Subject: Various requests for property located at 1626 & 1650 Arcade
Boulevard (P84-215)

SUBJECT: Infill Project - 1626-1650 Arcade Boulevard (P84-215)

APPLICANT	Booth Construction & Development, Inc., P.O. Box 13472, Sacramento, CA. 95813		
OWNER	Booth Construction		
PLANS BY	Raymond Vail & Associates, 1410 Ethan Way, Sacramento, CA. 95825		
FILING DATE	5/30/84	50 DAY CPC ACTION DATE	REPORT BY: FG:mm
NEGATIVE DEC.	6-25-84	EIR	ASSESSOR'S PCL. NO. 265-060-03.04.05.27. 28

SITE PLAN

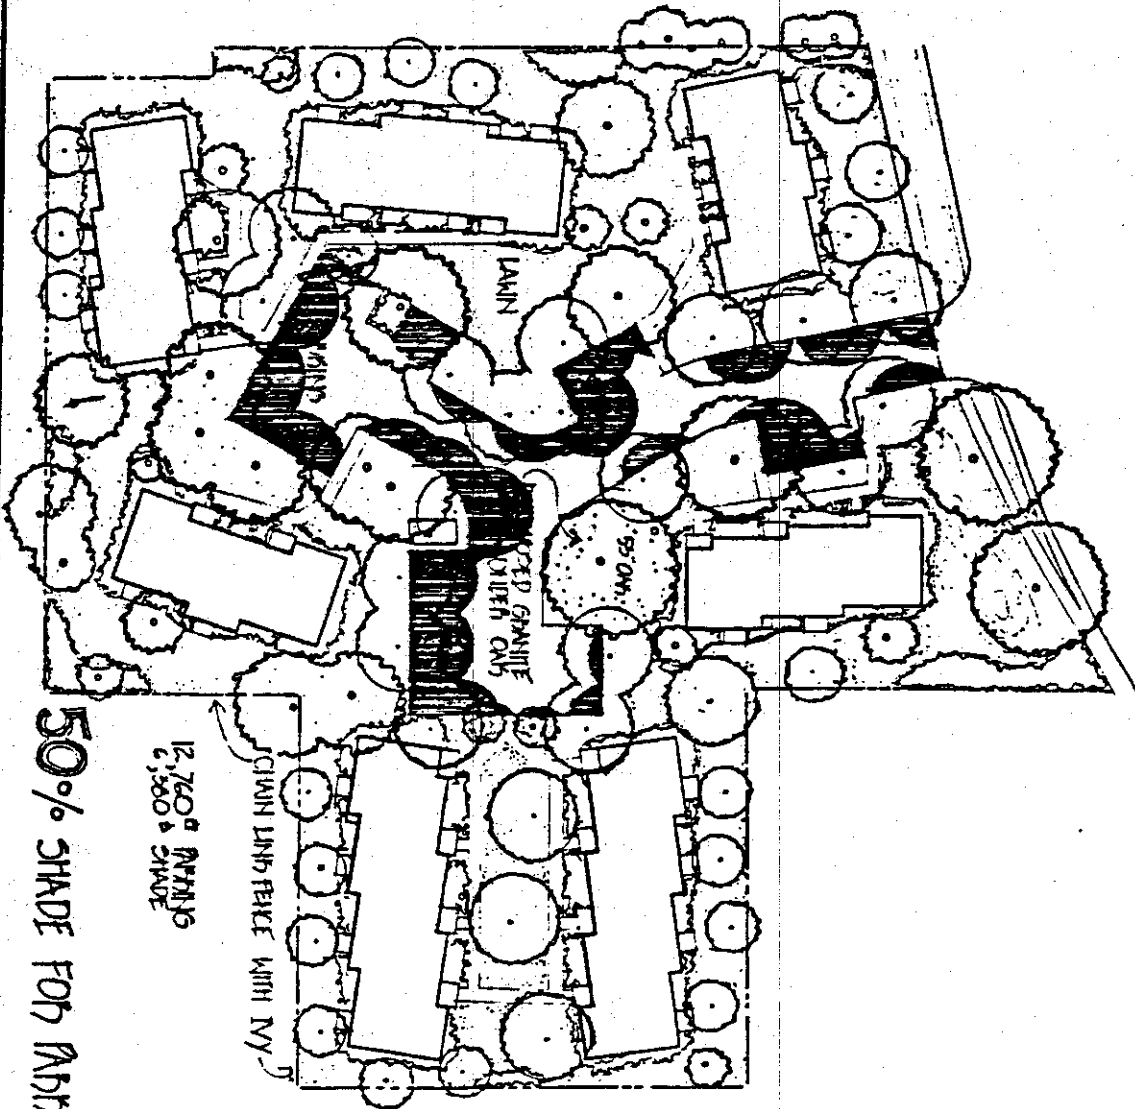
Another concern is the lack of a recreational or multi-purpose area for a project of this density. The applicant should consider the integration of a common area which might include benches, tables, horseshoe pit, BBO pit or tot lot (in the event that some units are rented to families with children.)

- a. The large Oak tree should have no grade changes within drip line. Minor changes at the outer edges should be discussed.

2. The applicant shall submit revised site plans indicating the location of a recreation/multi-purpose site to the Planning Director for review and approval prior to issuance of any building permit;

BOOTH CONST. & DEV., INC.	
2000 14TH ST. S.W. ALBUQUERQUE, N.M.	
DATE	11-11-57
FLOOR PLAN & ELEVATIONS	
FOUR UNIT APZ.

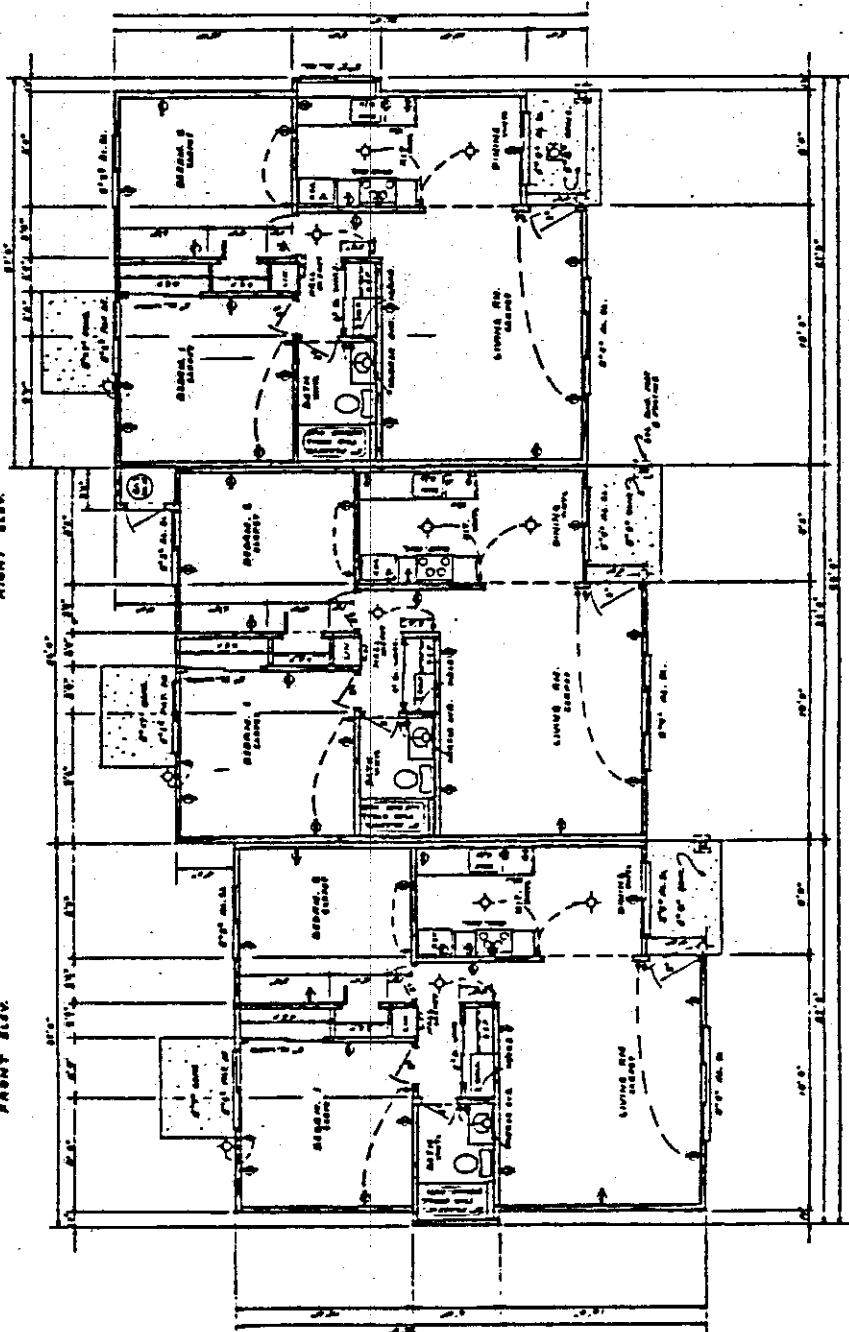
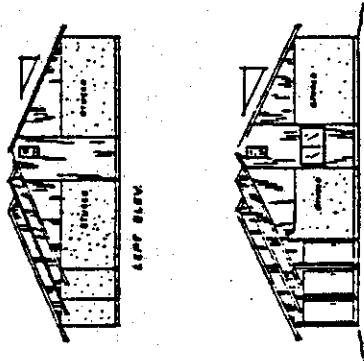
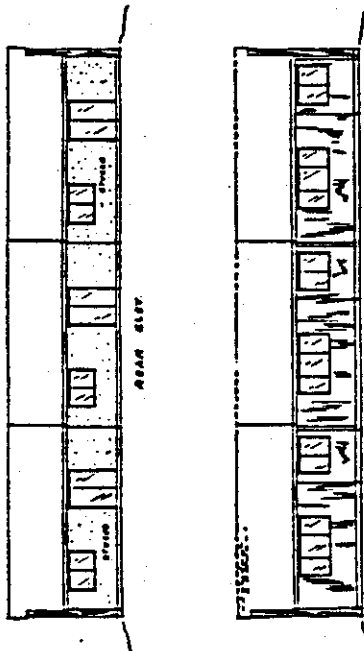
3. The building/floor plans and elevations have been reviewed and it is a concern that since the applicant's project may qualify for a 50 percent density bonus, serious consideration should be given to quality of design and construction materials. The applicant has indicated that buildings will be staggered to eliminate a monotonous 'in-line' pattern and roof lines will be constructed so as to provide varying roof elevations with textured shingles. The landscaping plan submitted by the applicant shows an intense use of berms along the street frontage and numerous existing and proposed trees which will tend to enhance the visual quality of the project.

4. The applicant shall submit a revised building/elevation plan indicating the correct roof line elevations and appropriate roofing material(s) of wood shingles, shakes or other suitable material(s). This plan shall be submitted to the Planning Director for review and approval prior to the issuance of any building permit.
